STAFF RECOMMENDATION 1403 Elmwood Avenue February 18, 2015

Application: New construction-porte cochere; Setback determination
District: Belmont-Hillsboro Neighborhood Conservation Zoning Overlay
Council District: 18
Map and Parcel Number: 10513011900
Applicant: Tyler LeMarinel, Allard Ward Architects, LLC
Project Lead: Paul Hoffman, paul.hoffman@nashville.gov

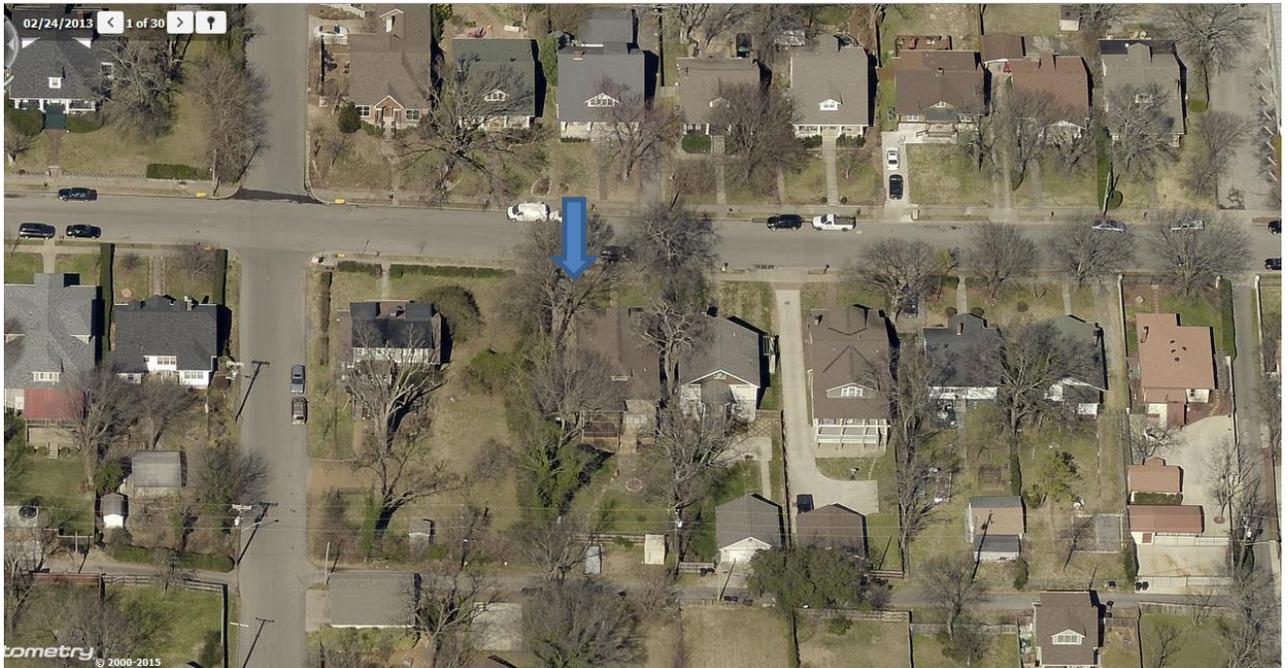
Description of Project: The applicant proposes construction of a porte-cochere onto the existing non-contributing house. The new construction would require a side setback determination from five feet (5') to one foot, six inches (1'6").

Recommendation Summary: Staff recommends disapproval of the application, finding that the conditions of the site do not support a reduced setback.
